**STAFF REPORT**  
**Planning Commission Meeting January 22, 2018**

**AGENDA ITEM NO.:** 3  
**PROJECT NUMBER / TITLE:** Application # 17-13

**REQUEST:** Special Use Permit (SUP) for satellite/off-site parking lot

**To:** City of Mission  
**From:** Olsson Associates  
**cc:** CAPROCQ KS Mission, LLC  
**Date:** January 10, 2018  
**Re:** Review for CAPROCQ KC Mission Parking Lot at 5700 Broadmoor Street

## Sheet C100

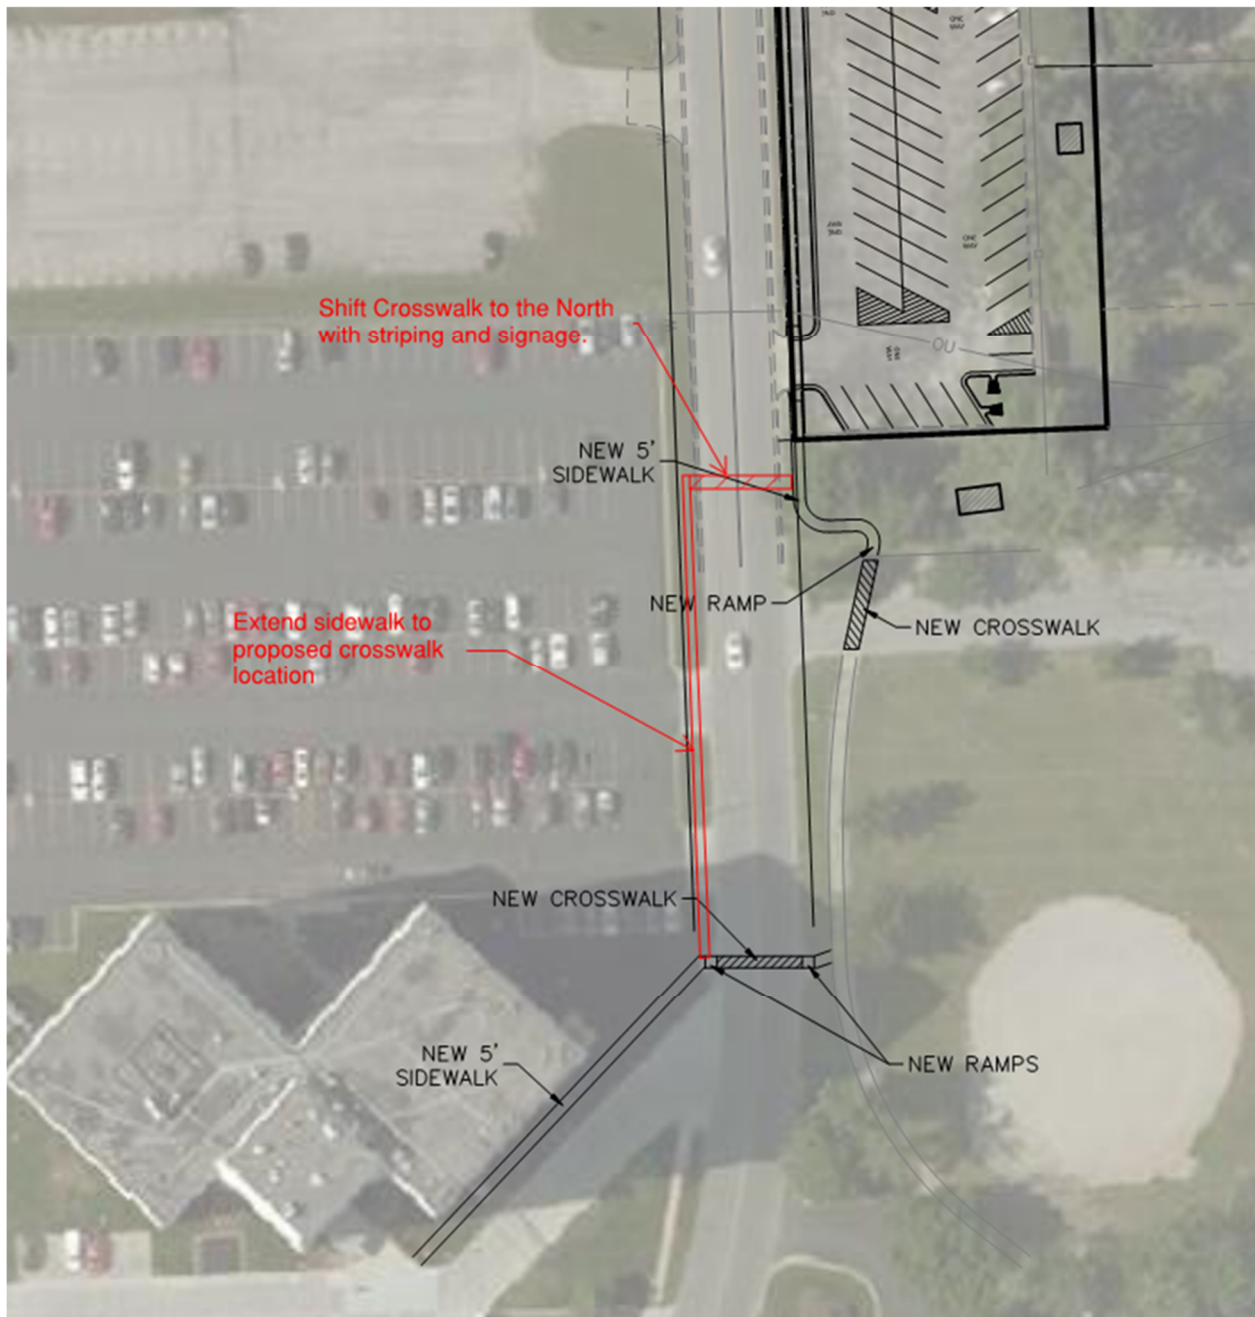
- The current crosswalk location (crossing Broadmoor St) is close to multiple drives which may conflict with crossing pedestrians.
  - Applicant should consider shifting north to be further from these driveways and be closer to the new parking lot and park entrance. (see attachment for possible schematic)
- Crosswalk location shall have Pedestrian Crossing Warning Signs with flashing beacons installed for both directions of travel. Signs shall have pushbuttons to activate beacons. Advanced warning signage in both directions further upstream may also be required depending on final crosswalk location.
- Crosswalk striping shall be installed per APWA standards.

**1 PHOTOMETRIC PLAN**  
1" = 20'-0"

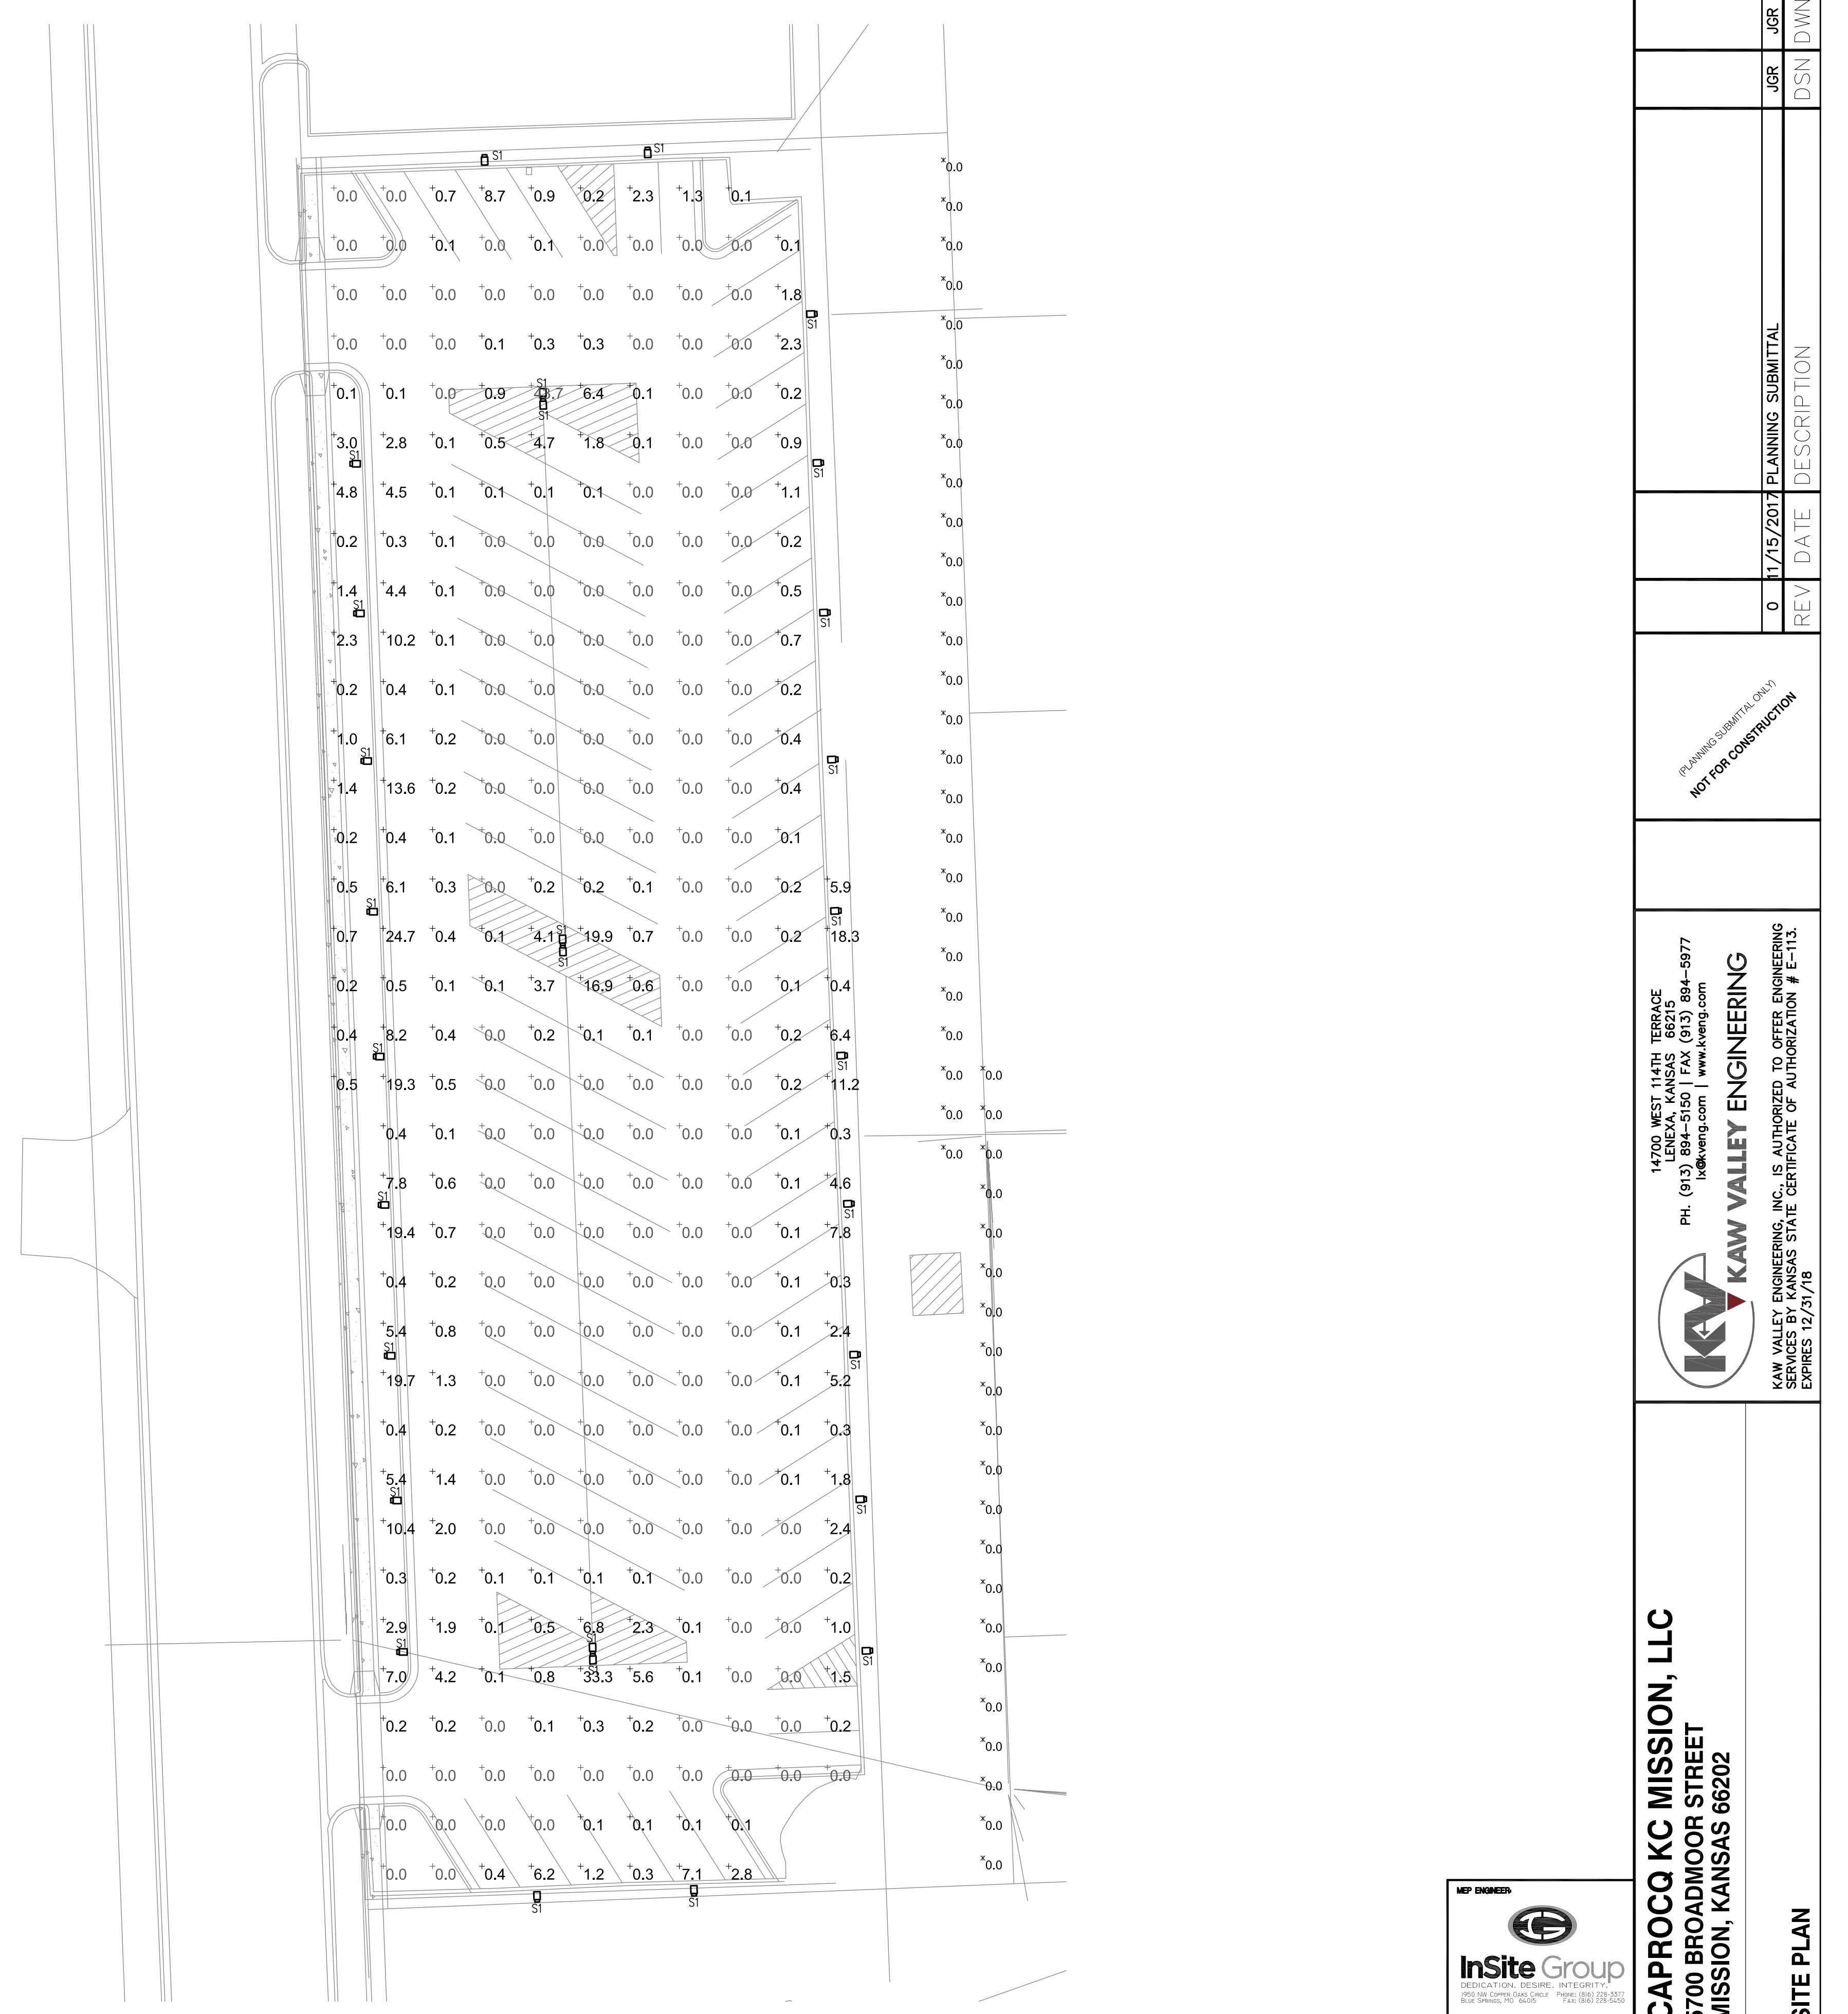
- Lamp output correlated color temperature (CCT) is specified as 4200K. Recommend 3200K or lower CCT adjacent to residences to minimize perceived glare associated with lamps that contain more blue light.

- Site Lighting – The existing parking lot is currently not lighted. Per discussions with the project engineer, the proposed parking lot lighting design is aimed at providing a level of security for the users at night that the ownership is acceptable with while maintaining sensitivity to the residential use to the east. The proposed lighting design does not fully meet industry standards for parking lots in regards to light levels. The owner and project engineer acknowledge this. Should safety or functionality of the parking lot become an issue or concern this can be addressed with the renewal of the Special Use permit.
